INDEPENDENT EXPERT ADVISORY PANEL FOR MINING

INTERIM ADVICE RE:

CLARENCE COLLIERY COAL MINE

918 & 920 PANELS EXTRACTION PLAN

Figure 3: The three surface subsidence profiles and magnitudes predicted in the EP.

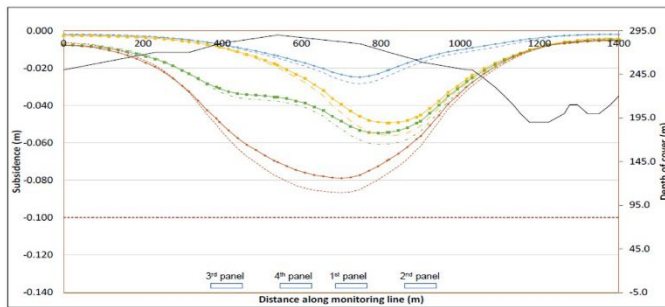
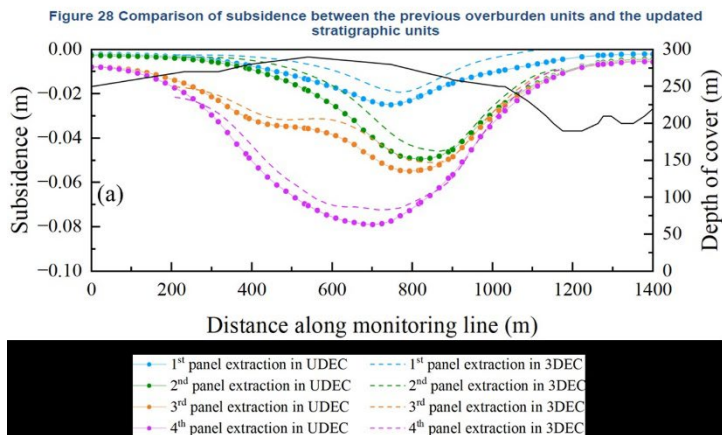
The surface subsidence profile predicted by the Strata² numerical model is shown in Figure 3(a). A basic limitation with the numerical modelling is that it is based on an elastic model; that is, a model which does not permit any strata failure. Both the peer reviewer and SCT (SCT (2023) identified this issue in their advices to Centennial.

The UNSW numerical modelling predicts a maximum subsidence of 87 mm over 918 and 920 Panels, as shown in Figure 3(b). This value is based on updated geological information. However, some sections of this and the other two UNSW numerical modelling reports continue to make reference to the previous value of 79 mm. The latest subsidence predictions based on the new 3-dimensional modelling being undertaken by UNSW (UNSW, 2024a) and presented in Figure 3(c) appear to revert to back to the superseded value of 79 mm as the point of reference.

Figure 4: Predicted stress profiles across the spine pillars of 918 and 920 Panels showing the significant increase stress magnitudes with the progression to numerical models that are more representative of field conditions.

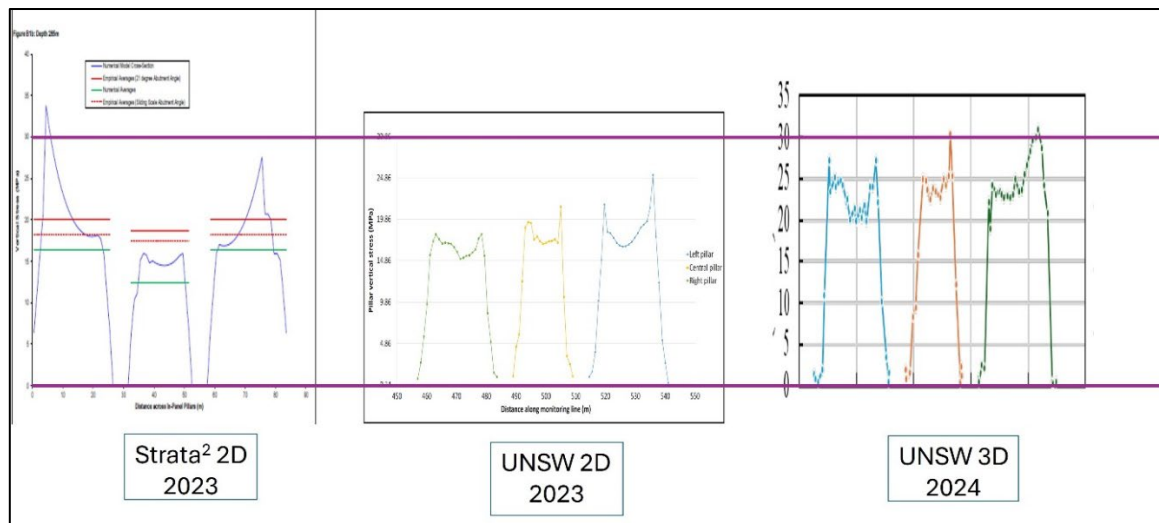
The Panel has compiled Figure 4 in order to compare the differences in stress magnitudes and distributions in the spine pillars predicted by the 2-dimensional model of Strata² (which did not permit the strata to fail and is now not relied upon) and the 2-dimensional and 3-dimensional models of UNSW (both of which permit strata to fail). The predicted profiles have been arranged in Figure 4 in a manner which results in them having approximately the same horizontal and vertical scale.

The difference in the stress magnitudes and distributions is pronounced (noting, however that the Strata² may be modelling pillar load at a different depth of mining to that of the two UNSW models). The 3-dimensional model predicts over a 30% increase (compared to the UNSW 2-dimensional model) in average pillar stress in the outer two spine pillar and over a 20% increase in average pillar stress in the centre spine pillar. It also predicts yielding of the floor strata to a depth of 4 to 6 m and the yielding of the pillar ribs to a depth of 5 m. Since, as is to be expected from subsidence engineering theory and practice and confirmed by the UNSW numerical modelling, pillar load and surface subsidence develop incrementally in the Clarence circumstances due to the stiffness of the roof strata being reduced with each incremental increase in overall panel width, it is quite plausible that the additional subsidence recently measured over 908 and 910 Panels could in part or total be due to the extraction of 906 Panel.

Figure 5 Predicted profiles of subsidence for Panels 918 and 920 (southern ends of panels)

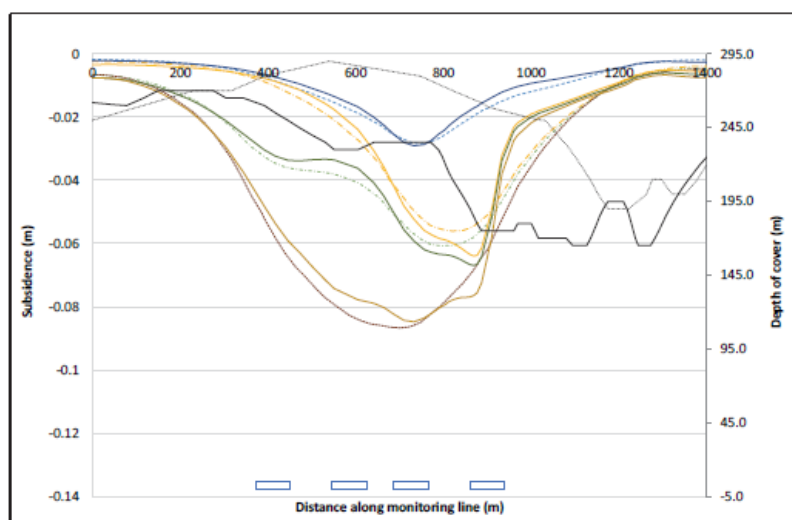
The two plots below are extracted from the SMP and show the subsidence behaviour over 918 & 920 Panels as predicted by the Strata² numerical model and that as predicted by the UNSW numerical model of July 2023, which was also peer reviewed by Em. Prof Hebblewhite.

The profiles were then developed based on a cross-section through the southern ends of the panels where the depths of cover vary between approximately 180 m and 260 m. The predicted profiles of vertical subsidence for Panels 918 and 920 are provided in the Excel spreadsheet in the email from the University of NSW (UNSW, 2023b) which has been reproduced in Figure 5 below.

Figure 4 Predicted profiles of subsidence for Panels 918 and 920 (mid-lengths of panels)

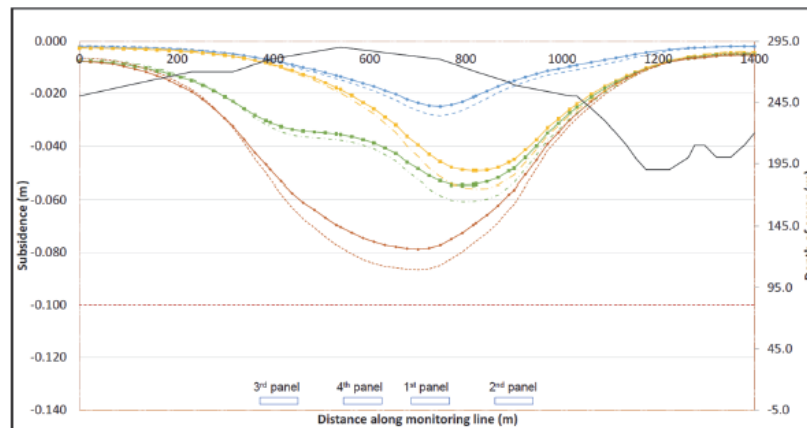
12. The order of extraction (918L, 918R, 920L and then 920R) results in a step change (~doubling) in subsidence development during the extraction of the final sub-panel, 920R. This is a result of the sub-panels not being extracted in a sequential order.

- i. How feasible is it to detect and prevent an exceedance of the approval condition based on the proposed monitoring program if, due to the order of extraction of the panels, an impending exceedance develops quickly as a step change?
